DOCKETED	
Docket Number:	25-OPT-02
Project Title:	Prairie Song Reliability Project
TN #:	268133
Document Title:	Save Our Rural Town Comments - Comment letter from Save Our Rural Town
Description:	N/A
Filer:	System
Organization:	Save Our Rural Town
Submitter Role:	Public
Submission Date:	1/5/2026 3:07:02 PM
Docketed Date:	1/5/2026

Subject: Supplemental Comments by Save Our Rural Town (SORT).

Reference: AB-205 Application Submitted for a Proposed Battery Energy Storage Project in Acton, CA.
Docket Number 25-OPT-02.

Figure 3. Map of Feasible Location Alternatives.

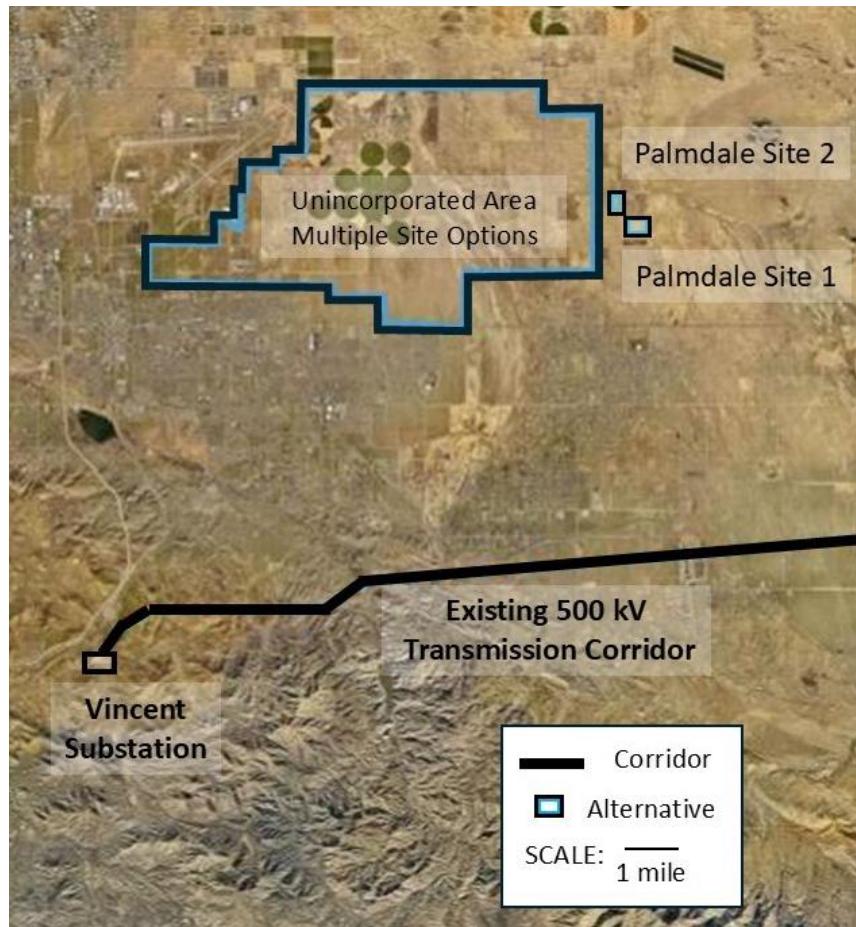
Alternative Location 2: The second alternative location that should be considered is a 26 square mile area in unincorporated East Antelope Valley that is designated for industrial purposes and where no residential uses are permitted. The area is depicted in Figure 3 and labeled as “Unincorporated Area”; it includes large tracts of vacant and irrigated lands that are adjacent to industrial uses and outside of mapped Significant Ecological Areas. These tracts are more than a mile from any residence, and since at least 1973, these lands have been designated as “Public and Semi Public lands” by the County General Plan. According to both the 1980 and the 2015 County General Plans, these tracts of land are “intended to be used for major utilities, transportation facilities, waste facilities, etc.” The tracts are owned by the City of Los Angeles and they lie adjacent to aerospace facilities and an airstrip owned by the US Government (known as Air Force Plant 42). Locating the BESS within one of these tracts of land would substantially lessen the significant noise, visual resource, and public safety impacts of the BESS Project; it would also substantially lessen all significant impacts stemming from land use conflicts. Because nearly all of these tracts lie outside of high and very high fire hazard severity zones, Alternative Location 2 substantially reduces the significant wildfire impacts posed by the BESS Project. Furthermore, a transmission interconnection can be easily accomplished because Alternative Location 2 is just 6 miles north of an existing 500 kV transmission corridor that terminates at the Vincent substation. The corridor has multiple single circuit 500 kV lines and, on the north side, a 220 kV line. By expanding the corridor or (better yet) upgrading the 220 kV line to a

Other alternative locations in East Antelope Valley are in the City of Palmdale adjacent to the unincorporated “Public and Semi Public Lands” described above. These locations (depicted in Figure 3 as “Palmdale Site 1” and “Palmdale Site 2”) are north of the existing transmission corridor described above; thus, interconnection to the Vincent substation can be accomplished largely with corridor modifications and franchise agreements. The sites are sufficiently large to accommodate a 30 acre BESS yard and 23 acre substation and are outside of any mapped Significant Ecological Areas. While portions of these sites have small drainage courses, there is sufficient space available to avoid these areas. These properties are thousands of feet from any residential structures reported on County property tax rolls and they are not in “High” or “Very High” Fire Hazard Severity Zones. As indicated in Figure 5, these parcels are zoned for industrial use and are adjacent to extensive utility scale solar facilities. Some of these parcels may be owned by the City of Los Angeles; others are privately held. Given the zoning on these sites, their separation from residential areas, and their CalFire designation, these Alternative Locations will substantially lessen the significant environmental effects posed by the BESS Project.

Figure 6. Excerpt of Revised BESS Project Site Plan (Annotated in Red).

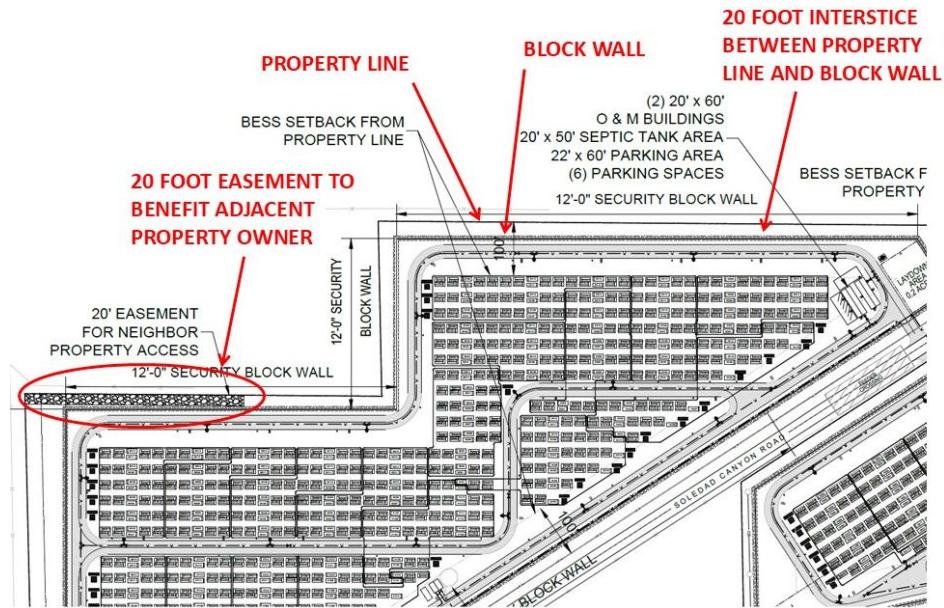
The revised Application does not appear to address concerns raised by SORT pertaining to emergency access²² and the fact that the BESS Project eliminates secondary access to adjacent residences. Recently, SORT learned that the primary access for adjacent residences is prone to erosion and is thus substandard; therefore, the BESS Project will eliminate the only reliable access route for Acton residents. This significantly adverse impact cannot be ignored, particularly since it can be easily mitigated. Specifically, the revised Site Plan²³ indicates that, along the northern wall surrounding the western the BESS yard, there is a 20 foot wide interstice between the property line and the block wall (see Figure 6). SORT presumes this interstitial area is intended for landscaping, but it could be configured and slightly widened to accommodate both landscaping and an access road that can be used by emergency vehicles and surrounding residents. The Applicant would provide an easement granting public access rights along, across, and over this access road. As Figure 6 shows, the developer proposes such an easement along the north wall to benefit one resident²⁴; this easement should be extended to benefit other residents and, for trail purposes, it should surround the entire development (which will mitigate the trail impacts that SORT previously identified²⁵).
